## NORTHERN BEACHES LOCAL PLANNING PANEL

**WEDNESDAY 3 FEBRUARY 2021**

ITEM 3.1	DA2020/1163 - 24 WANDEEN ROAD, CLAREVILLE - CONSTRUCTION OF A DWELLING HOUSE INCLUDING A SWIMMING POOL
AUTHORISING MANAGER	Rodney Piggott
TRIM FILE REF	2020/765981
ATTACHMENTS	1 Assessment Report 2 Site Plan & Elevations

**Image 3. Standing in the Lounge Room, facing north-west (red box indicates approximate location of the roof form of the ground floor level alfresco area).**

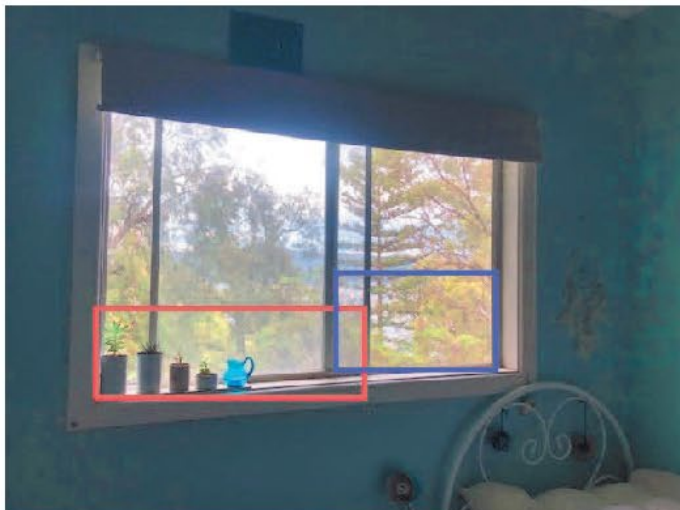
The areas of main concern relate to the views obtained over the western side boundary line, in both a seated and standing position within and external to the dwelling - refer to Image 1. and images below.

#### Comment to Principle 3:

As the rear of the proposed dwelling does not extend beyond the dwelling at 26 Wandeen Road, and as a result of the significant slope of the land meaning the proposed dwelling sits lower than the dwelling at 26 Wandeen Road, the areas of non-compliance are not seen to considerably obscure the views across the western side boundary line from windows 2 and 3. However, the views currently enjoyed from one bedroom (window 1) is likely to be impacted as a result of the proposed development. Although, as indicated in the above View Loss Assessment, this is a negligible impact.

**Image 8. 3D impression of proposed development (subject site is central, 26 Wandeen Road is above the subject site).**

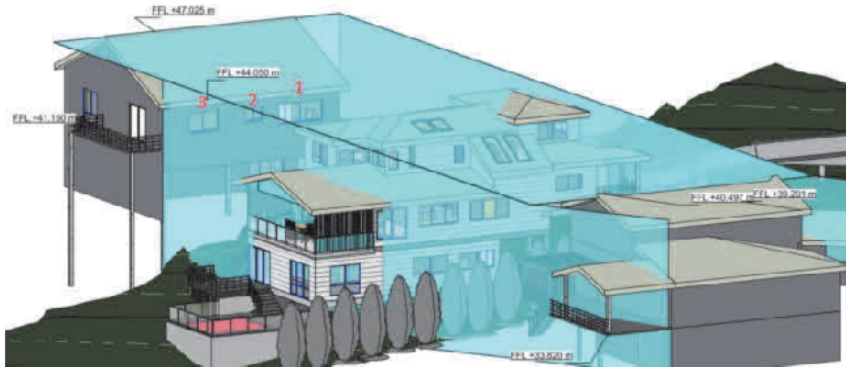
The architectural plans provided to Council (prepared by Rise Projects, dated 30 November 2020), specifically drawing no. 6.7.2 Rev D 'Height Limitation' (see image below), provides a 3D image of the subject site and adjoining properties from a south-easterly perspective. This 3D image is useful to

understand the potential view impact as a result of the proposed dwelling. The windows along the western elevation for 26 Wandeen Road are labelled as 1, 2 and 3. Windows 1 and 2 are for the bedrooms and window 3 is for the living room.

**Image 1. Western Elevation.**

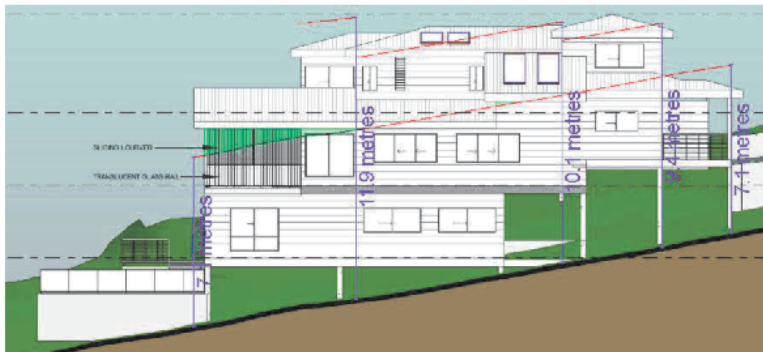
The objectors have raised concern with regards to multiple areas of numeric non-compliance with controls within P21 DCP, of particular concern is the non-compliance with the building envelope requirement.

A small portion of the external wall and a portion of the proposed privacy screen for the alfresco area along the western elevation protrudes through the prescribed building envelope (see Image 1. Western Elevation). Further, a portion of the external walls and a part of the master bedroom windows along the eastern elevation protrude through the prescribed building envelope (See Image 2. Eastern Elevation).

Where the building footprint is situated on a slope over 16.7 degrees (that is, 30%) a variation to the numeric requirements of this control may be considered on a merit basis. In this instance, the building footprint is located on a slope in excess of 30%, as such, a merit based assessment is considered below.

**Figure 3 - Areas of Building Height Non-compliance are shown in Red (Source: Benson McCormack Architecture)**

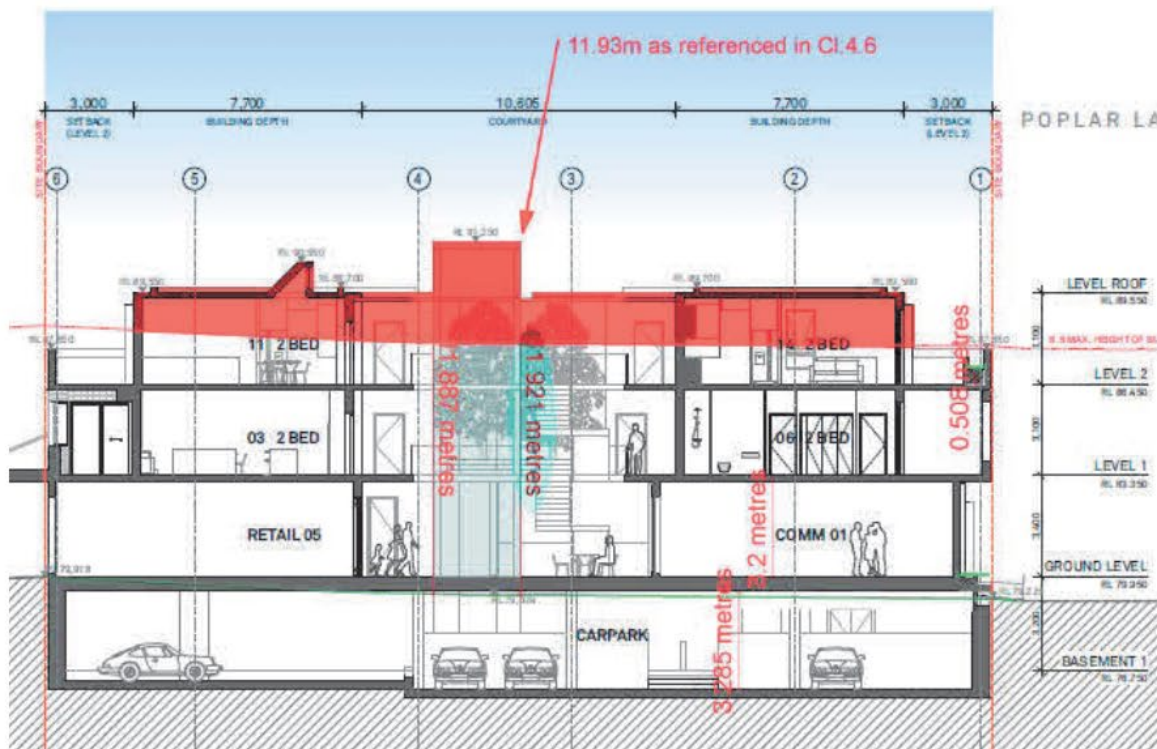
Development Standard:	Height of Buildings
Requirement:	8.5m
Proposed:	Building - 10.23m

Lift overrun -11.93m
Percentage variation to requirement:	Building - 20.35%
	Lift overrun - 40.35%
